TECHNICAL BULLETIN

OUTPUT COUPLING
LOOP REORIENTATION
FOR USE WITH THE
4KM100LF-H &
4KM150LF-H

COLLECTOR COIL RING INSULATOR FOR EXTERNAL CAVITY TV KLYSTRONS

OUTPUT COUPLING LOOP FOR UHF-TV KLYSTRONS

The sketches below show the differences between the old and the new Collector Coil Ring Insulators.

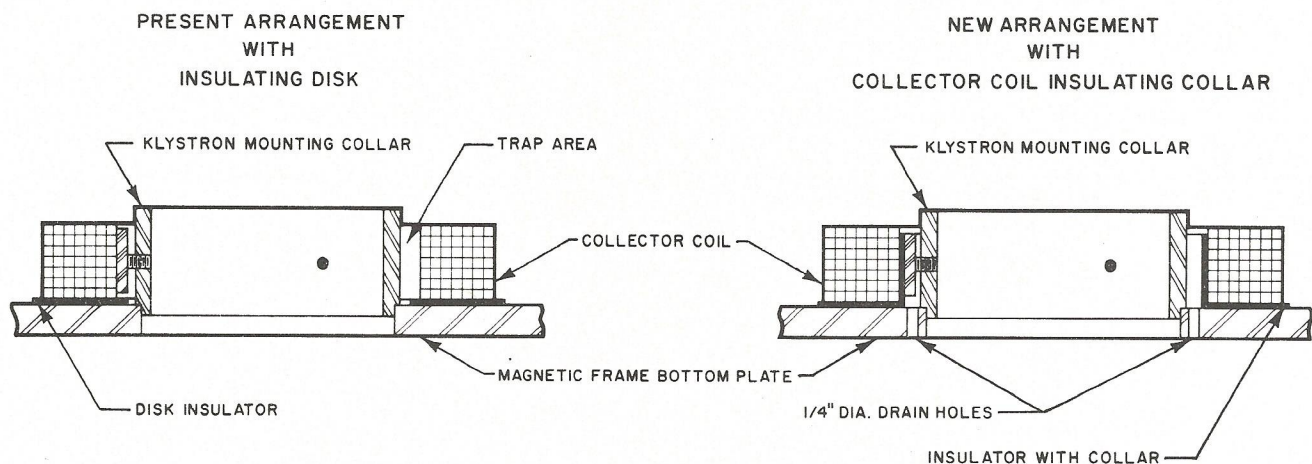
Collector coil failures have occurred in some older installations due to spilled coolant collecting between the coil and the klystron mounting collar. When the coolant is not removed, it can cause corrosion buildup in the trap area, shown below at the left. Also, a leakage path can be created between the coil and frame which may eventually result in insulation breakdown and severe coil damage.

The new insulator is designed to eliminate the trap area. Together with 1/4" drain holes which should be drilled in the frame bottom plate close to the klystron collar, it also reduces the likelihood of any coolant collecting between the coil and collar.

After refurbishing the collector coil and bottom plate of the frame, place the new insulator around the klystron mounting collar as shown in the righthand sketch below. Reposition and center the collector coil using the three insulating pads and adjusting setscrews.
